[Docket No. 2004-SW-04-AD]

#### Airworthiness Directives; Bell Helicopter Textron Canada Model 222, 222B, 222U, and 230 Helicopters

**ACTION:** Notice of proposed rulemaking (NPRM).

**Figure 1. Main Rotor Hub Assembly**

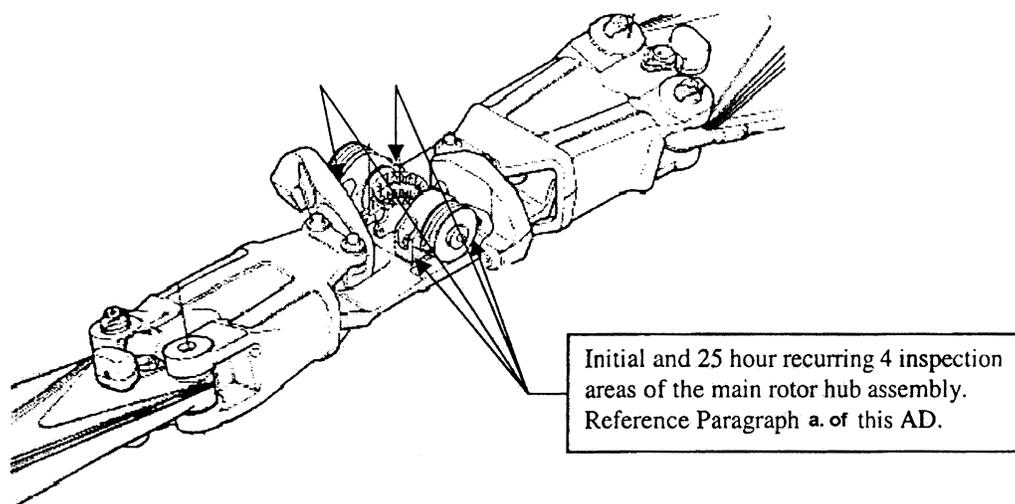
- (a) Within 50 hours time-in-service (TIS) or by the next scheduled inspection for the hub assembly, whichever occurs first, and thereafter at intervals not to exceed 25 hours TIS, using a 10X or higher magnifying glass, visually inspect the main rotor yoke (yoke)

for a crack, fretting or buffer deterioration in the four areas around the flapping bearing attachment bushings as shown in the following Figure 1 of this AD:

(1) If a crack is found, before further flight, replace the yoke with an airworthy yoke.

(2) If fretting or buffer deterioration is found on the yoke in the areas shown in Figure 1 of this AD, before further flight, disassemble the hub assembly and further inspect the yoke with a 10X or higher magnifying glass in the four areas shown in Figures 2 and 3 of this AD.
